*Addendum 2  
Issued on September 6, 2016*

**BID NO. 2016-002  
FOR  
BAYWALK PLAZA AREA DESIGN (SOUTH SIDE ONLY)**

**Issued by:** North Bay Village

SHEET NUMBER  
**C-400**

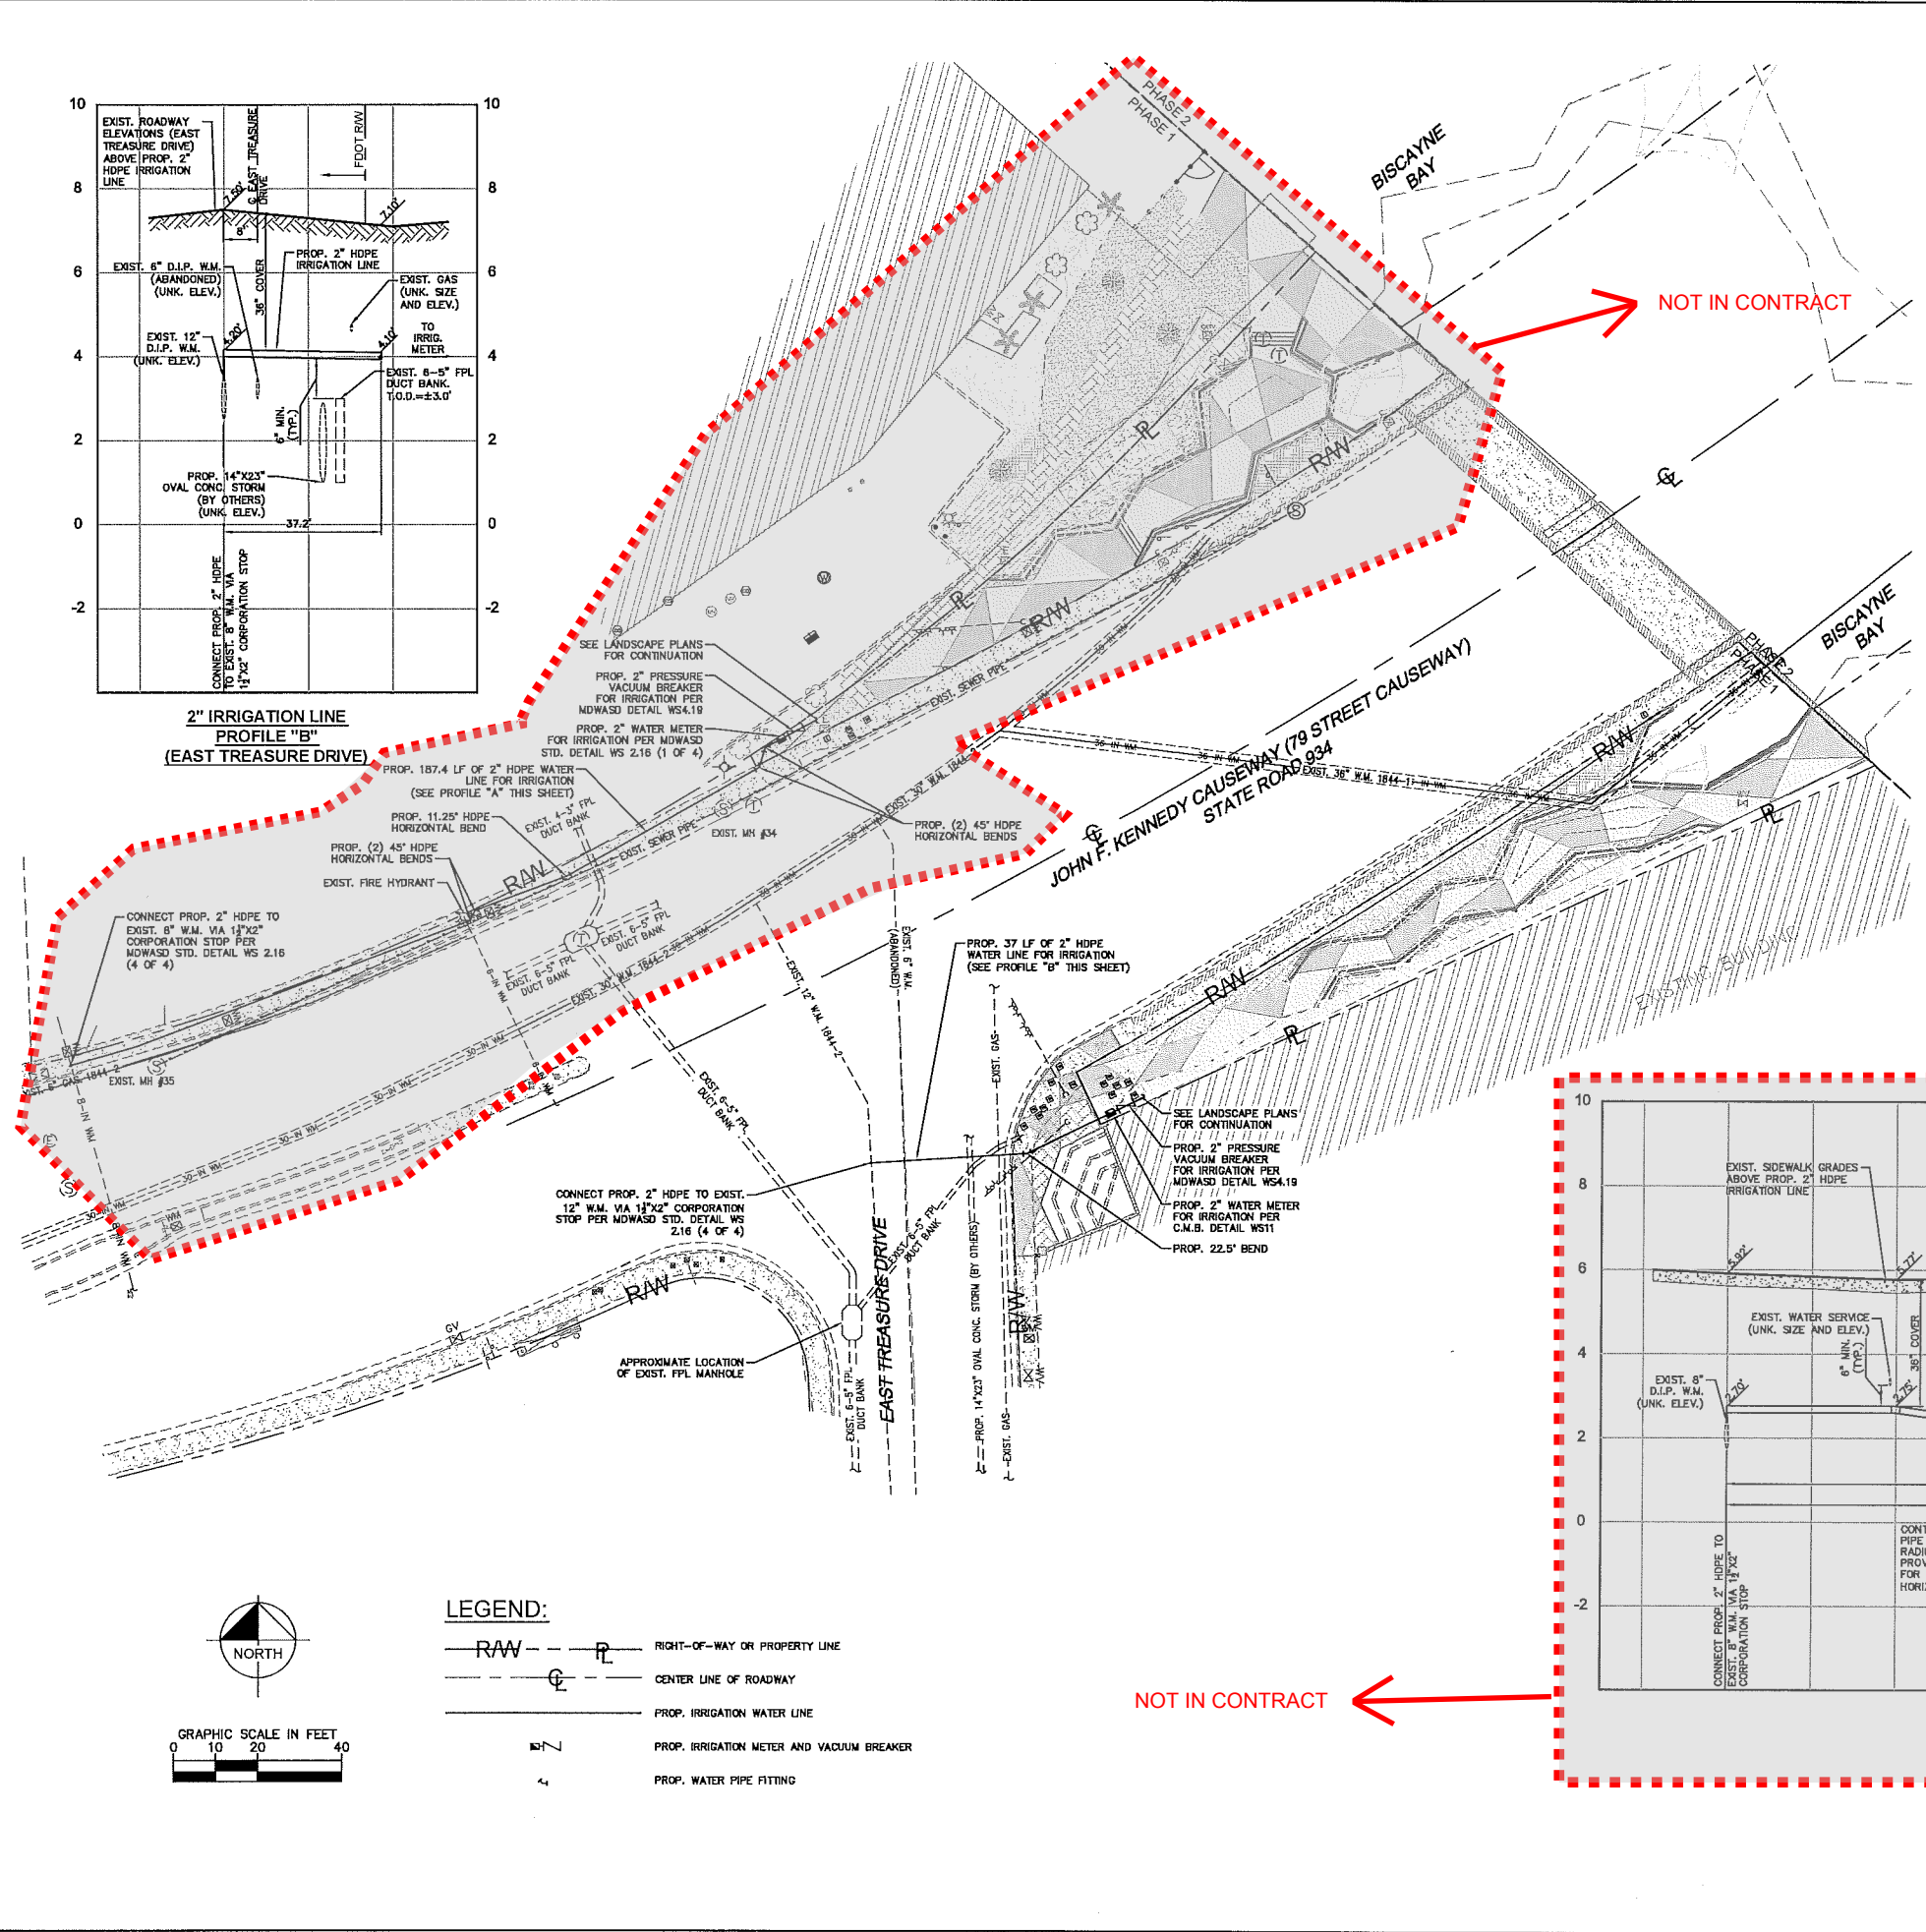
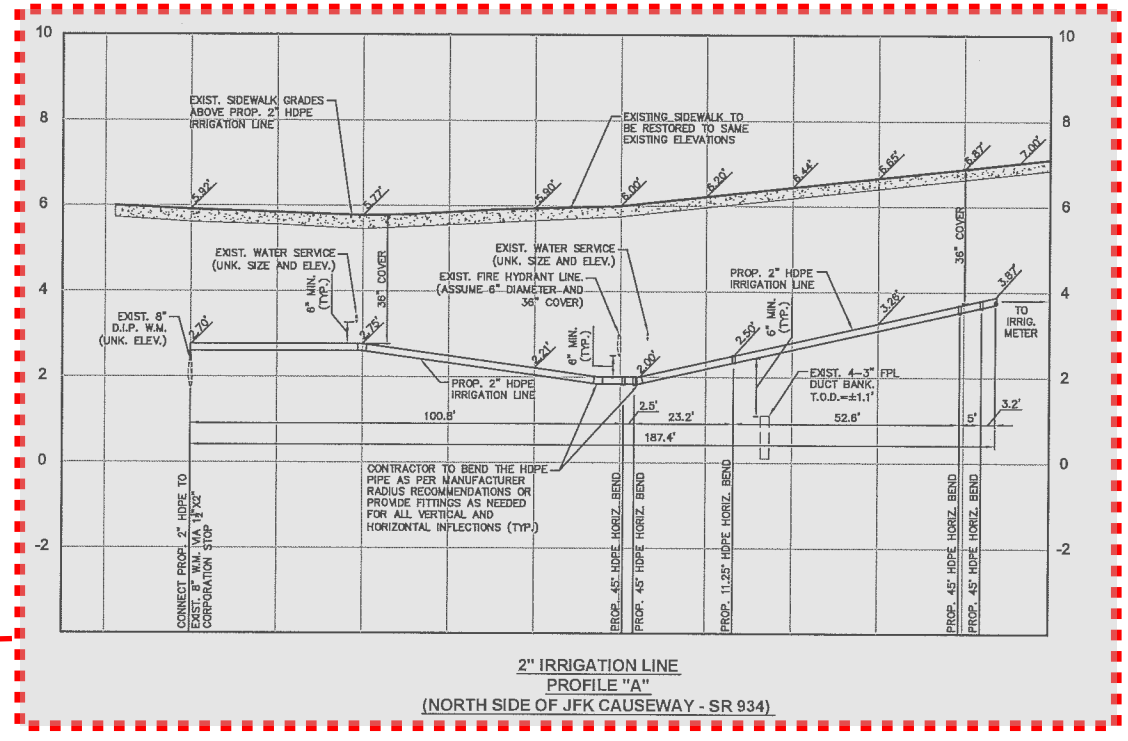
2) **Question:** Sheet C-400-2" Irrigation Line Profile B detail shows a proposed oval concrete storm pipe. Is this part of the south side improvements?

**Response:** The pipe reflected on the profile is not proposed by Kimley-Horn. It is labeled as "By Others" and therefore not part of the plans prepared by Kimley-Horn and not part of the work to be done by the contractor as part of the south side improvements.
